TO: Troy Kelts, Galloway & Company
FROM: Stacey Nerger, Senior Planner
DATE: November 15, 2023
SUBJECT: The Exchange Lot 1 – Site Plan
Review Comments 01

Staff Comments 01
SP23-080; The Exchange Lot 1
Site Plan
November 15, 2023

PARKER EXCHANGE BUILDING SITE DEVELOPMENT PLAN

2 AREA LIGHT DETAIL
SCALE: NOT TO SCALE

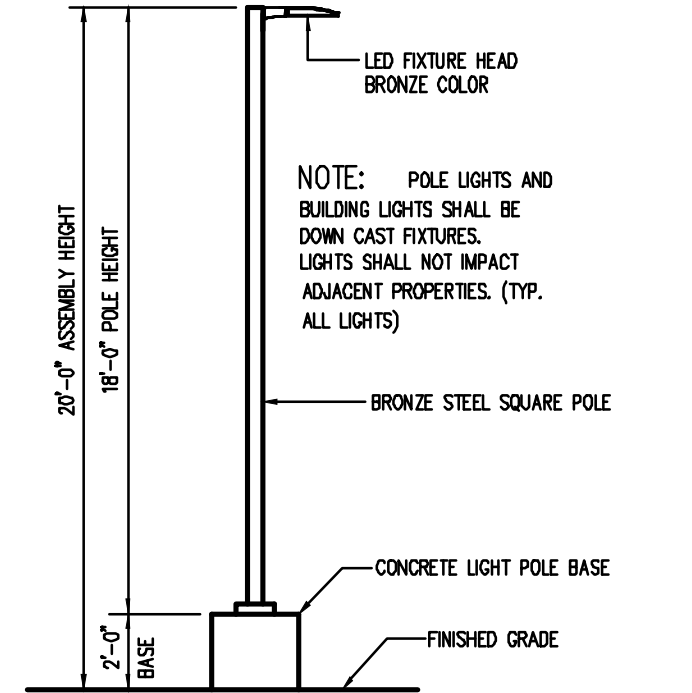
Maximum footcandles at the property boundary is 1.13.10.140(c)(7)

Is this existing or proposed?

This does not match the image in the luminaire schedule.

Are these footcandles from lights on site or street lights. If these numbers are coming from the street lights you can either remove that light from the calculations or add a note.

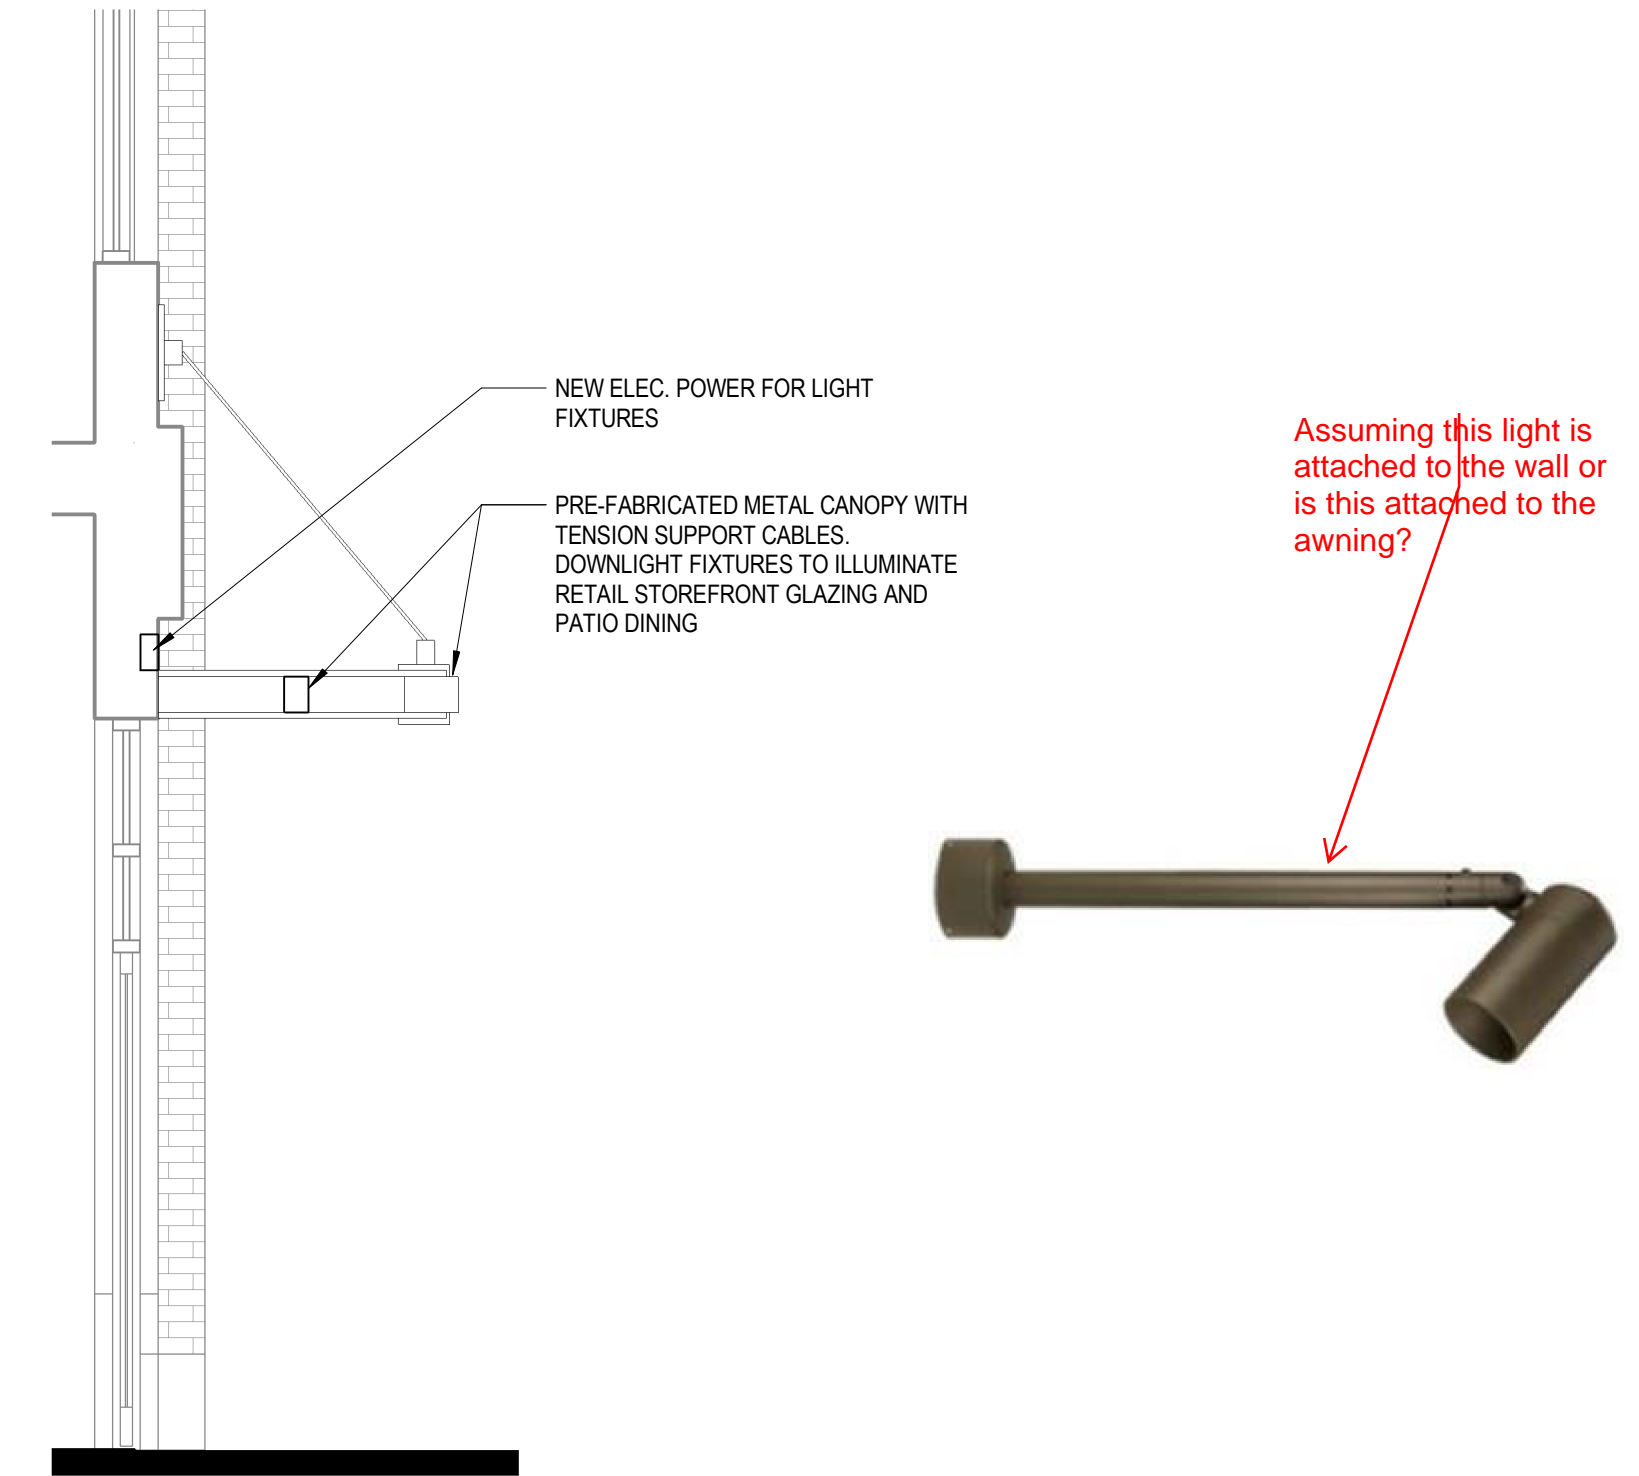
Please note signage requires a separate permit. Please remove all signage from the elevations to avoid confusion.

Are these windows new? If new, please add a note. If existing, no changes needed.

Are these areas proposed to be stucco similar to the other areas, or painted brick? If painted brick, please add note to state so.

Where is this pointing? Up Lights are not permitted
